CCF/PPF/CHF URC2 PCB Upgrade 94A0571 Kit

Service Bulletin

ALN151, 28 July 2010,
Rev. B , 17 September 2010

PREVIOUS CHF FEEDBACK WINDING CONNECTIONS

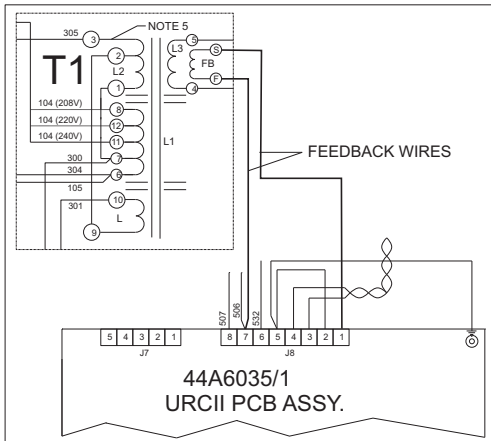
1. Turn regulator manual control to 'off'.
2. Turn off power to regulator.
3. Locate J8 on the URC2 44A6035/1 main PCB.
4. Remove and cap or tape off the original feedback wires at J8-1 and J8-7.

5. Neatly tie-wrap original feedback wires into the wire harness.
6. Install the 4" jumper wire between J8-1 and J8-8. J8-8 will now have two wires connected.

7. If previous feedback modifications have been performed, confirm that there is a wire between J8-2 and J8-5. Confirm there is no wire between J8-2 and J8-7. See Figure 1.1. Verify that the wiring matches diagram 43A3788.

PREVIOUS CCF/PPF FEEDBACK WINDING CONNECTIONS

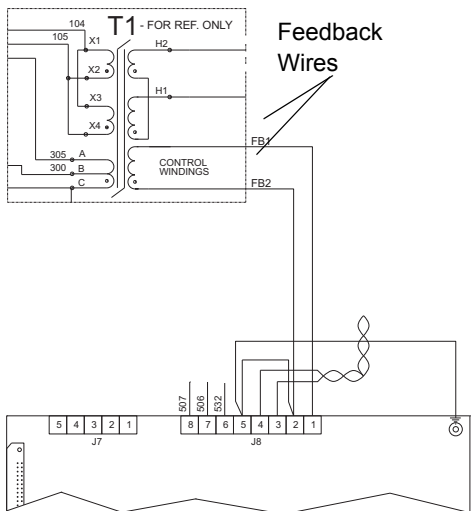
1. Turn regulator manual control to 'off'.
2. Turn off power to regulator.
3. Locate J8 on the URC2 44A6035/1 main PCB.
4. Remove and cap or tape off the original feedback wires at J8-1 and J8-2. Neatly tie-wrap original feedback wires into the wire harness.

5. Install the 4" jumper wire between J8-1 and J8-8. J8-8 will now have two wires connected.
6. If previous feedback modifications have been performed, confirm that there is a wire between J8-2 and J8-5. Confirm there is no wire between J8-2 and J8-7. Verify that the wiring matches diagram 43A3788.

Figure 1.1. 43A3788 - CCF Feedback Winding Connections

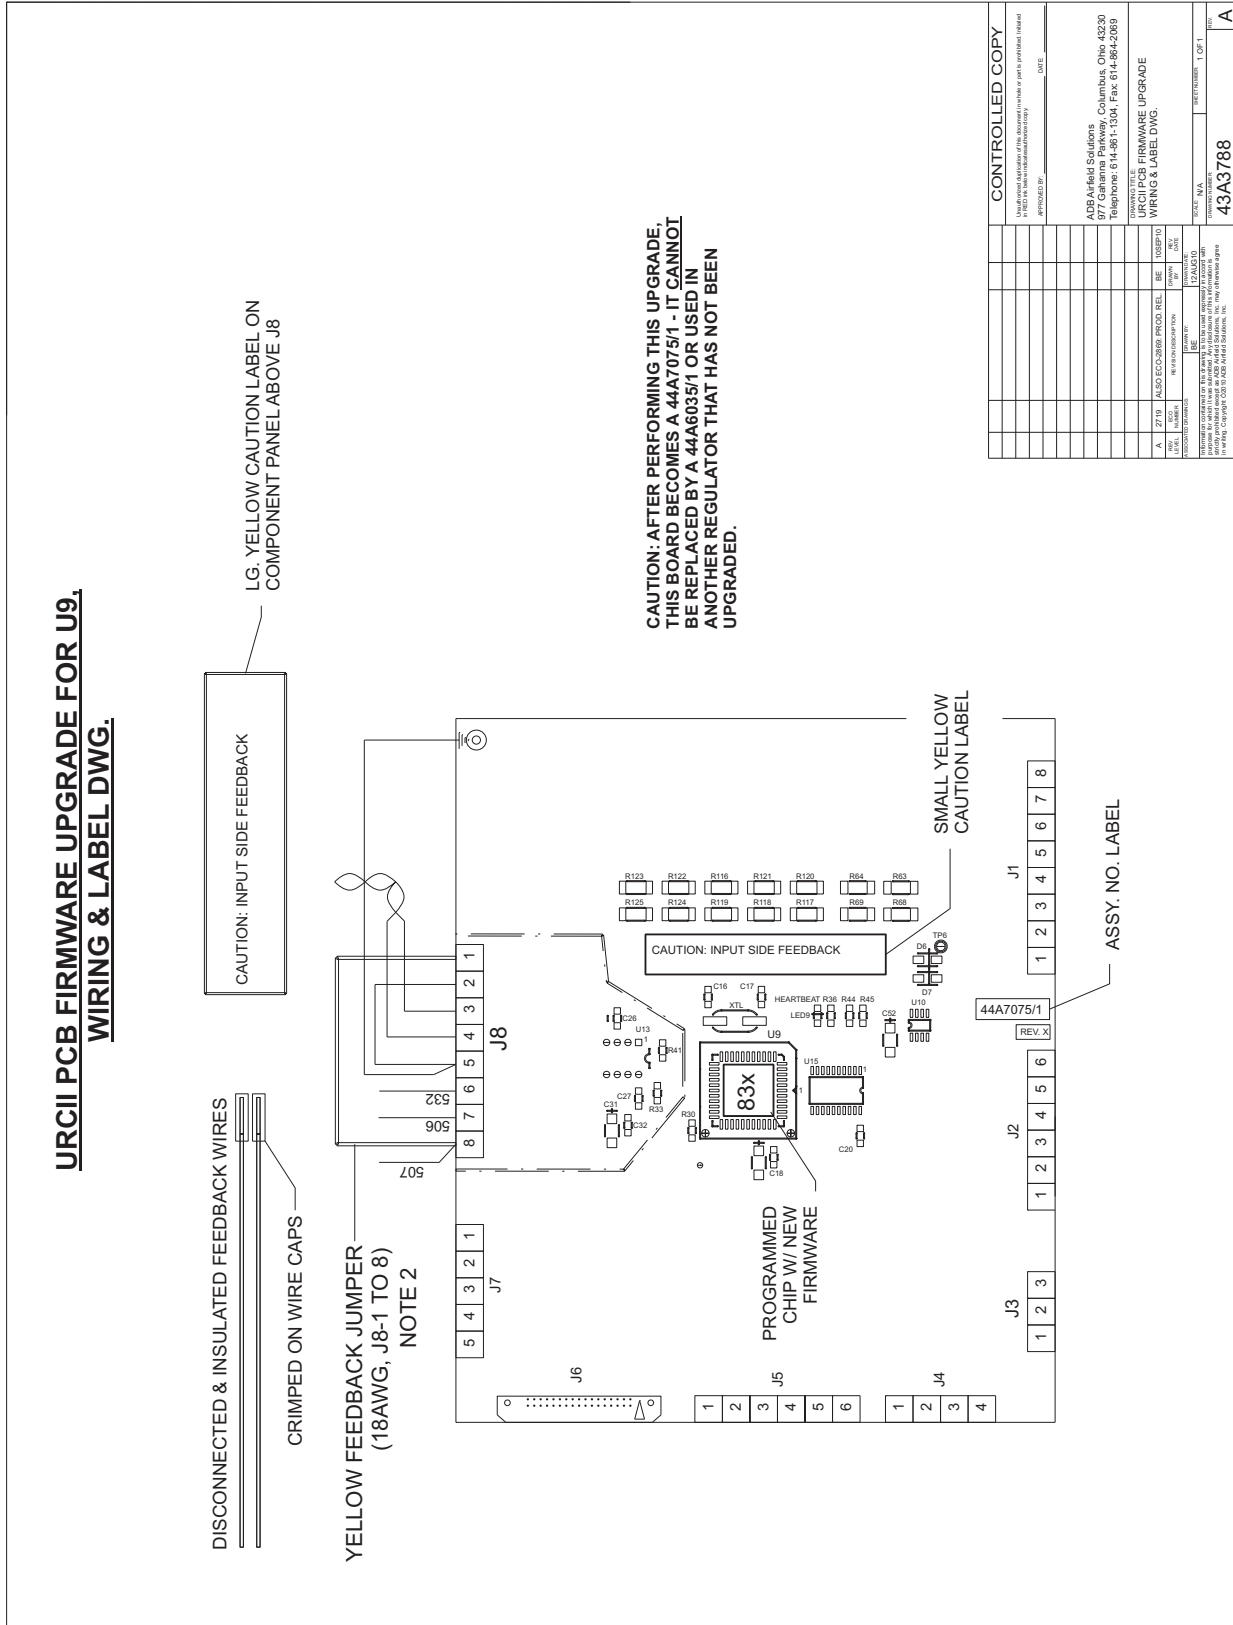
10. Clean surfaces prior to applying labels.
11. Place assembly sticker over silkscreen on the PCB showing ASSY #44A7075/1". See Figure 1.1.
12. See Figure 1.1. Place large feedback wiring change sticker on white panels near PCB J8 connector which states "Caution: Input side feedback". Place small feedback wiring change sticker on the URC PCB below J8 connector which states "Caution: Input side feedback".

9. Place assembly sticker over silkscreen on the PCB showing ASSY #44A7075/1". See Figure 1.1.
10. See Figure 1.1. Place large feedback wiring change sticker on white panels near PCB J8 connector which states "Caution: Input side feedback". Place small feedback wiring change sticker on the URC PCB below J8 connector which states "Caution: Input side feedback".
